3856 Terrace Lane & Unassigned Parcel 0-15097 Crystal Beach Drive Fort Erie

4.22.9.14 Multiple Parcels between Crystal Beach Drive and Terrace Lane (3856, 0-15084, 0-15085 & 0-15086 Terrace Lane and 0-15097 Crystal Beach Drive).

Official Plan and Zoning By-Law Amendment Application for

Figure 1: The development superimposed on the WWTP.

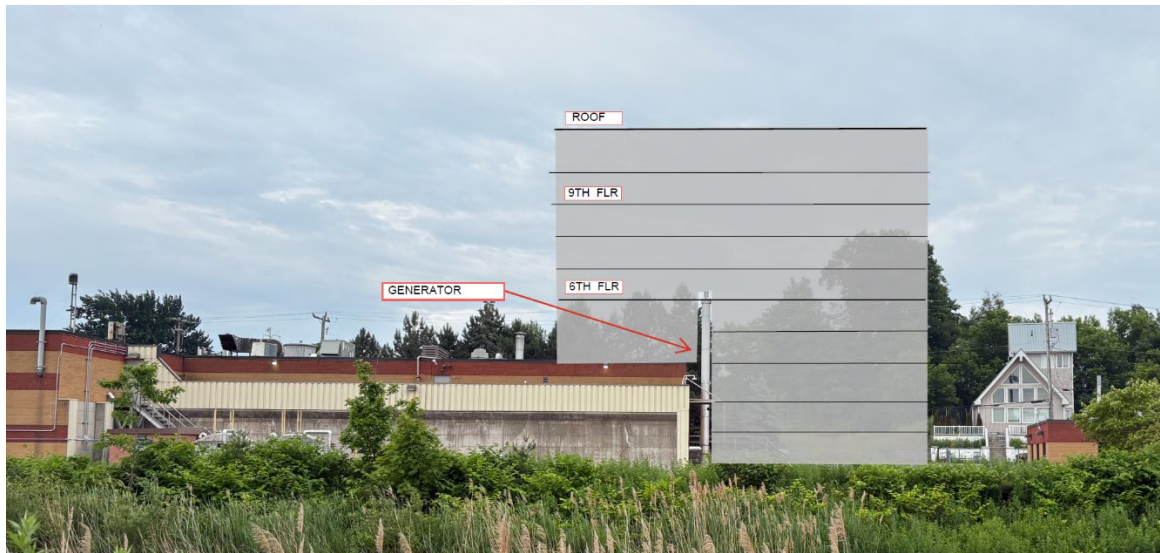
This underrepresents the potential impact. The diesel generator stack is 18 metres above grade at the WWTP, which itself sits approximately 1.5 metres below the proposed building's ground floor elevation. Therefore, the top of the stack would align roughly 16.6 metres above the proposed building's ground floor—approximately at the 6th floor level. As such, residents from the 6th floor upward would qualify as “elevated receptors” and could be exposed to emissions during periodic testing or emergency operation. This exposure warrants a more thorough evaluation than is currently presented.

See Figure 1 below.

The RWDI report's treatment of the WWTP's diesel generator operation is overly simplistic and does not adequately address real-world scenarios. The generator is not merely an emergency backup that operates infrequently—it is tested monthly for one hour and is relied upon during power outages. A notable example occurred during the week-long blackout that began around 3:30 p.m. on December 23, 2022. During that event, the WWTP's emergency generator ran for approximately nine hours before failing due to a fuel shortage. This left the facility inoperable and raised significant concerns about public health and environmental protection.

Figure 2:

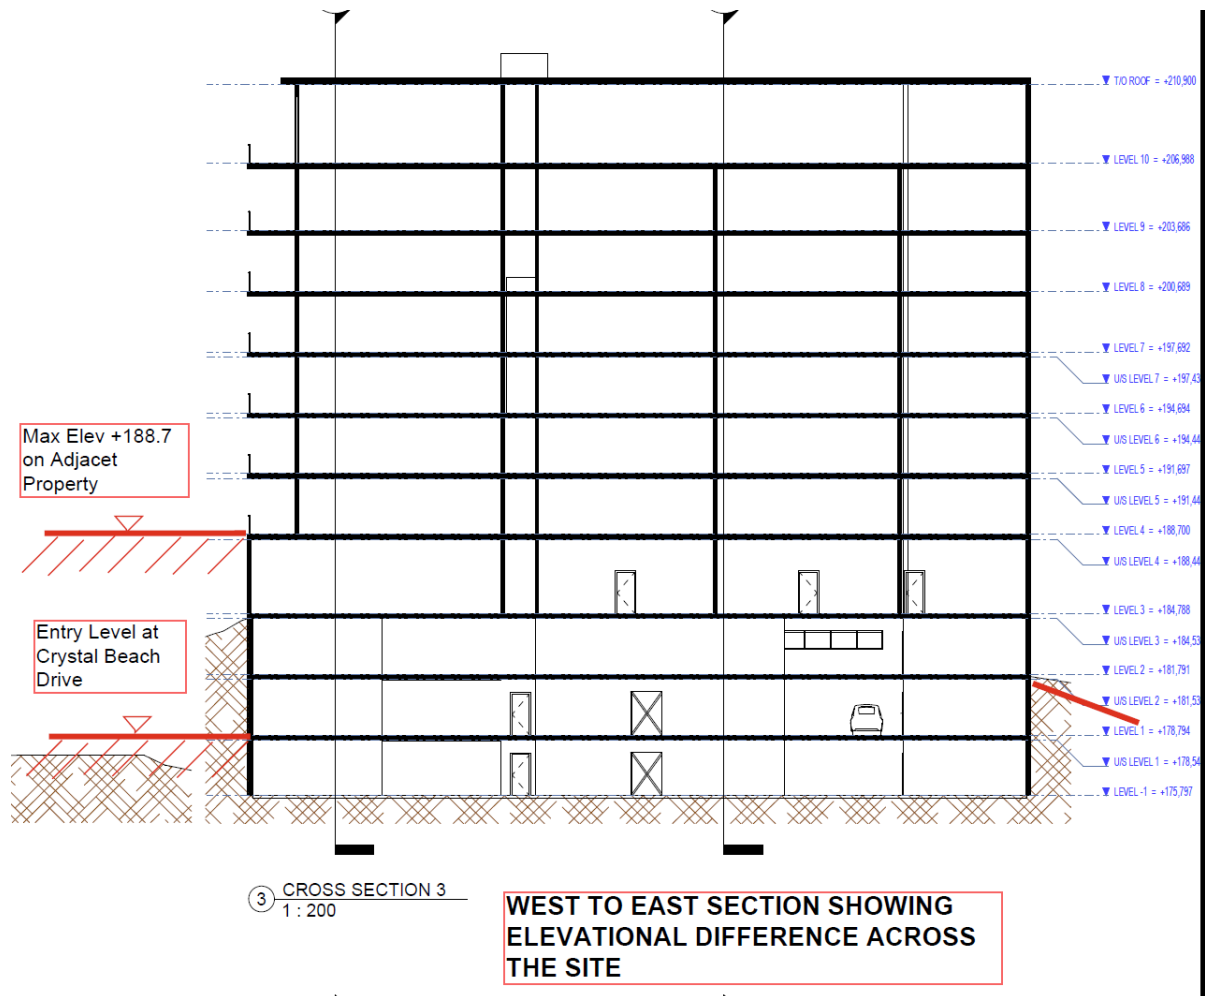
The report recognises that excavations will be to the property lines and that shoring will be required and *"the upper levels of the shoring system would have to be supported by a 'tie-back' arrangement drilled at an angle into the Cherty Limestone rock under the adjacent properties to the east and west and also under the road at Crystal Beach Drive where utilities have to be avoided."* Alternately, should permission for tie-backs be refused by the adjacent property owners then a temporary raker and waler system of shoring within the confines of the property under development will be necessary, but would have to be removed when the concrete floors slabs are completed and have attained their specified strength.

Lateral soil pressure increases with depth so the lateral pressure from the west will be greater than the lateral pressure from the east which act facing each other. Tie-backs resist the lateral forces on each side. In the absence of tie-backs the unequal forces in opposite directions must be resisted by the structure and this would require significant east-west concrete shear walls which are not account for in the floor plans and would impede circulation within the below grade parking level and the first three floors above grade. See Figures 2 and 3 below.

Figure 3: Existing Soil Profile Along West Property Line

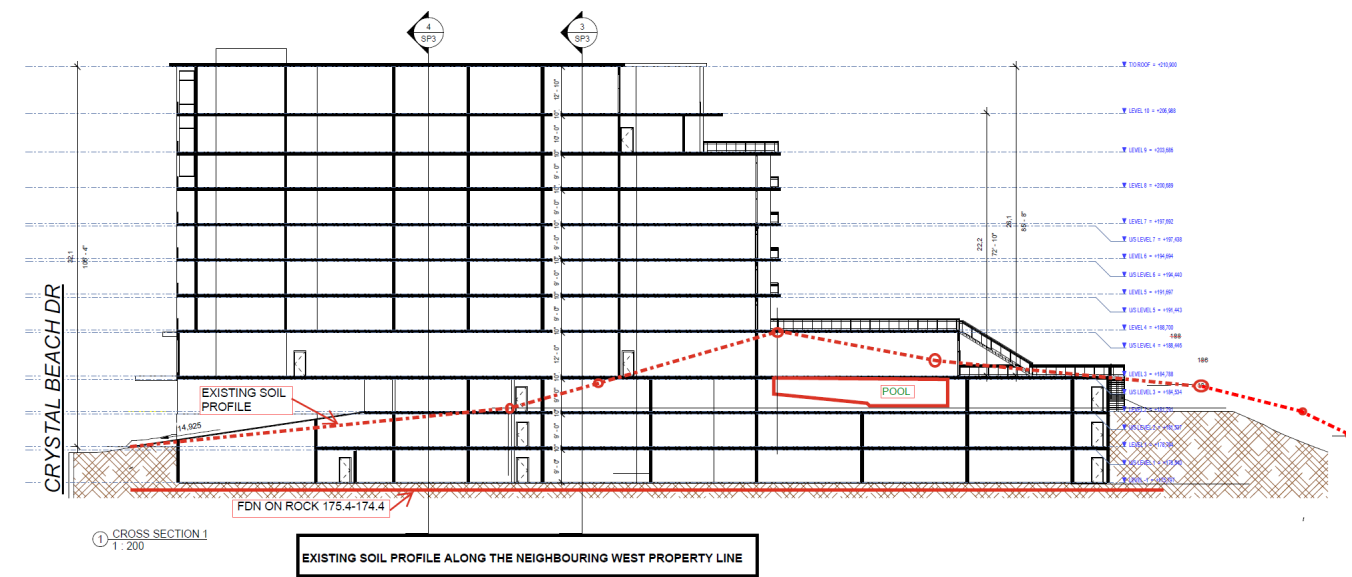
- the need for stabilisation of the sandy soil overlying the rock, and erosion control measures;

- “Unfortunately, because of the lot coverage there will be little vegetative stabilization (usually by planting native grasses, shrubs, and trees) which is a natural and effective way to anchor the soil and reduce surface erosion.”
- “Water management is equally important. Effective drainage systems, such as swales or French drains, help redirect water away from the site, reducing water saturation in the soil. Permeable surfaces and rainwater harvesting systems can further reduce surface runoff that might otherwise contribute to erosion. “
- “Ongoing monitoring and maintenance are essential after construction to ensure the long-term stability of the site.”
